CAPRICORN MUNICIPAL DEVELOPMENT GUIDELINES

2022 MEETING 03 MINUTES

Date and Time: 1 April 2022 11:00 am

D05.18. PIPE MATERIAL

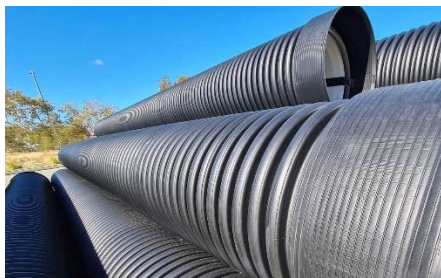
- LSC is suggesting use of corrugated polypropylene drainage pipes.

- C221 Section C221.04 mentions FRC and RCP pipes but not Plastic.
- Current Section D05.18 reads as follows.

- It is noted that Hydra Storm supplies pipe as follows:
 - Manufactured in accordance to AS – NZS 5065
 - Available from Diameter Nominal (DN) 225mm to 600mm
 - Manufactured from recycled HDPE

- C221 will need to be updated at the same time as D5.
- Richard mentioned that he is meeting with a representative from Iplex next week where he will get additional information and specifications.

Richard to collate information and specifications and send to committee for further discussion at next meeting.
